## ADDENDUM NO. 1

Date: April 5, 2011  
To: Shortlisted Contractors  
From: Mike Ambre - Project Manager  
Reference: West Campus Interior Improvements  
Utah Valley University – Orem, Utah  
DFCM Project No. 10295790  
Subject: **Addendum No. 1**

**Addendum No. 1**

Project: Utah Valley University  
 West Campus Interior Improvements

ARCHITECTURAL PHASE:  
CONSTRUCTION DOCUMENTS  
SHEET TITLE:  
**WALL & MISC. DETAILS**  
**AE502**  
SHEET 21 OF 25

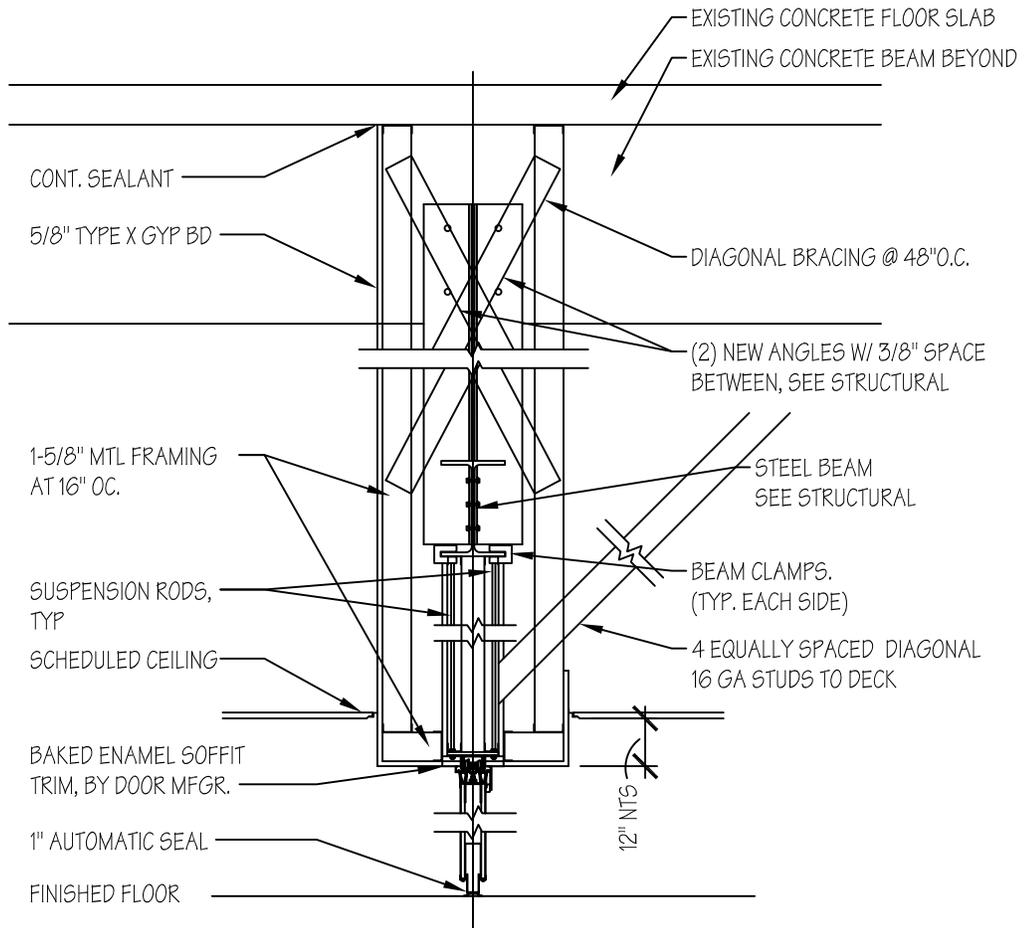
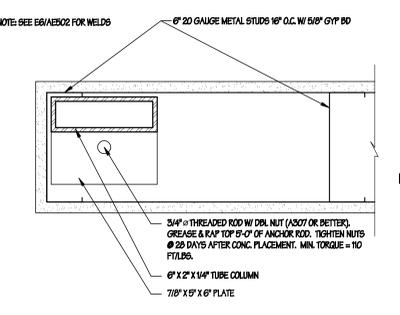
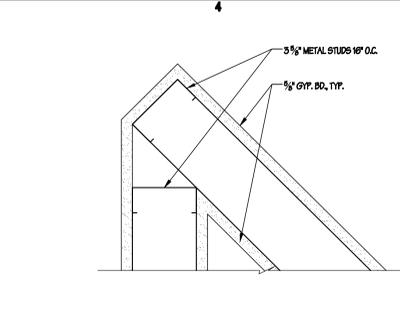
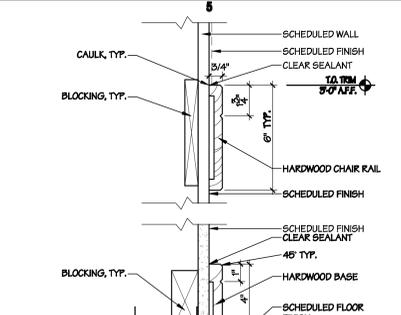
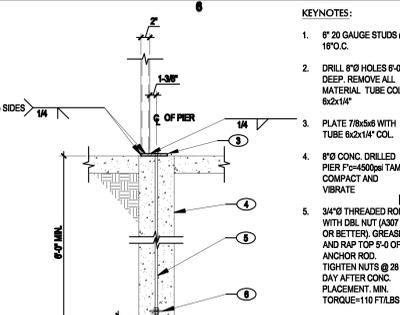
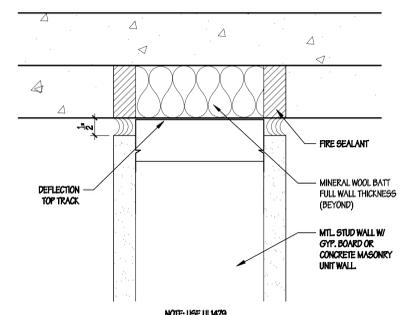
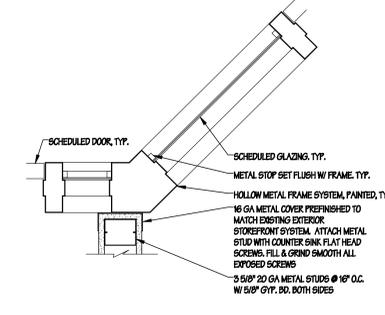
1-28	AE502	This sheet has been replaced in its entirety, refer to the attached PDF file of AE502 for revisions to this sheet indicated by revision cloud.
1-29	AE503 Alt #1	Enlarged Plan D4 - Accessible toilet stall to have accessible toilet partition doors, graphically they are shown to small on the 1/8 scale plan.
1-30	AE601	Detail D6 indicate erroneous grid numbers, ignore these references they are incorrect.
1-31	AE601	Detail D5: Replace with new detail attached to this addendum
1-32	AE601	For detail D5 coordinate Structural detail D1/SE101 for structural support of folding partition.
1-33	AE601	DOOR SCHEDULE Change height of door 132B (operable panel partition) to 9'-0".
1-34	AE601	A3 Door Frames: Add note: At door 144 the frame will go in an existing CMU wall. Ship door frame knocked down. Head to be 4" high. Frame to be 7-5/8" deep to cover cut CMU. Punch and dimple frame for drilled anchors. Fill dimples with auto body compound and sand smooth. Head piece to be installed immediately after opening is cut. Shore head in place, then install jambs. Face weld head and jambs and grind smooth to match other frames.
